S U B M I S S I O N: Hofbauer  
a written submission by way of objection to DA 2020/0442

Re:  
231 Whale Beach Road Whale Beach NSW 2107  
DA 2020/0442

WRITTEN SUBMISSION: LETTER OF OBJECTION  
Submission: Hofbauer

*Demolition of the existing Apartment and Retail Building and Construction of a New Shop Top Housing Development*

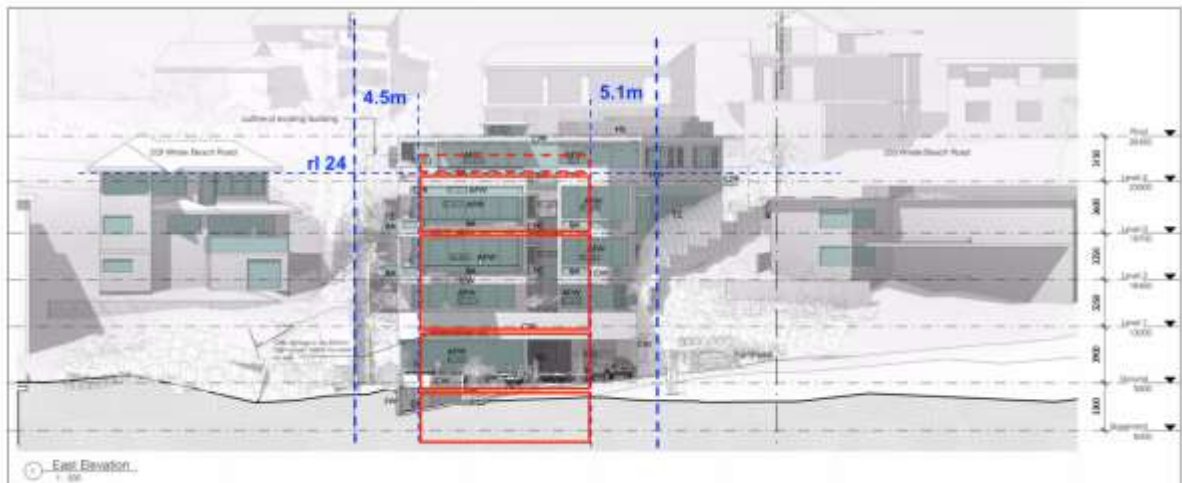
The proposed Storey Heights are excessive to ADG guidelines, and these could decrease to:

- 3.6m storey heights, with 3.3m ceiling for Commercial;
- 3.0m storey heights, with 2.7m ceiling for Residential, and
- 2.7m storey heights, with 2.4m ceiling for Carpark.

Allowing for 2 x Commercial @ 3.6m [7.2m] + 3 x Residential @ 3.0m [9.0m] + 1 Carpark @ 2.7m, the overall building height would require 18.9m building height above the basement slab. To achieve a RL 24.0 wall height to match neighbouring sites, the Basement would need to be lowered to RL 5.1m.

An amended scheme could deliver:

- Basement RL 5.1m Carparking, provide additional double stackers to increase carparking
- Ground RL 7.8m Commercial & Carparking
- First RL 11.4m Residential
- Second RL 14.4 Residential
- Third RL 17.4 Residential
- Fourth RL 20.4 Commercial [Back of pavement WBR @ RL 20.75 and 21.5 balustrade not to extend past 13m contour]
- Roof RL 24.0 Roof [not to extend past 15.5m contour, preferably a greater setback to reduce the bulk]
- Plant RL 25.2 Plant, maximum permissible of any plant or lift over run, positioned at western side facing Whale Beach Road to avoid view loss.

The amended sectional profile would present wall heights that align with the wall heights at #229 Whale Beach Road at RL 24.0.

Figure 3F.3 New development adjacent to existing buildings should provide adequate separation distances to the boundary in accordance with the design criteria

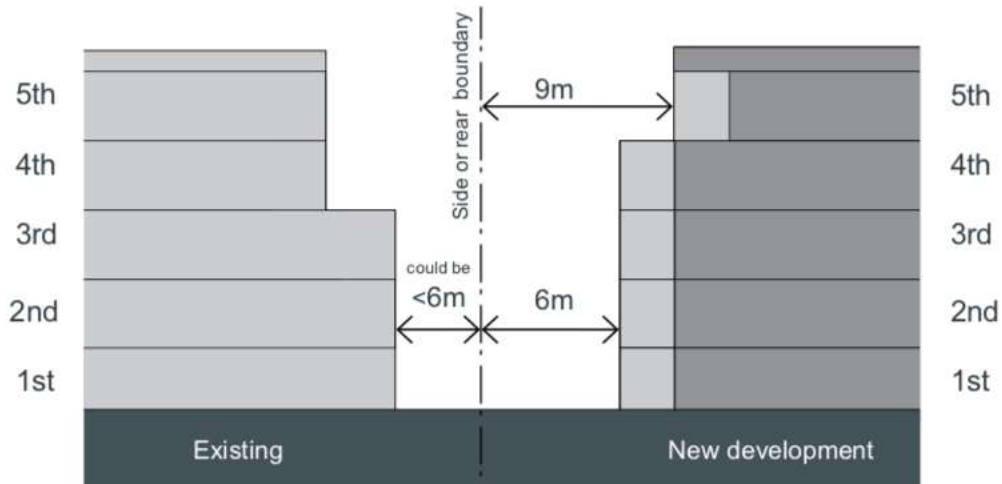
Non-compliant to controls

ADG: 6m side & rear setback requirement v Proposed 1.8m

Council should insist on a 6m side setback to ADG controls, or a dimension closer to that control.

## Boundary conditions

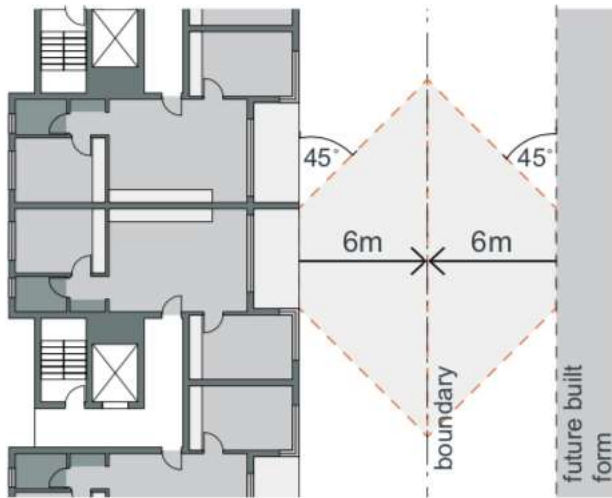
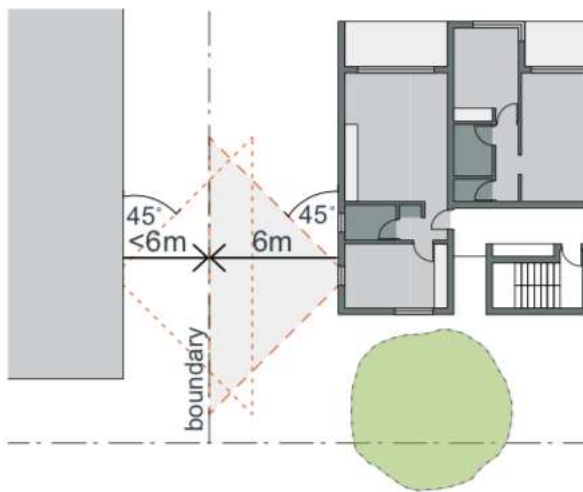
ADG: Control 6m boundary condition setback v Proposed 1.8m
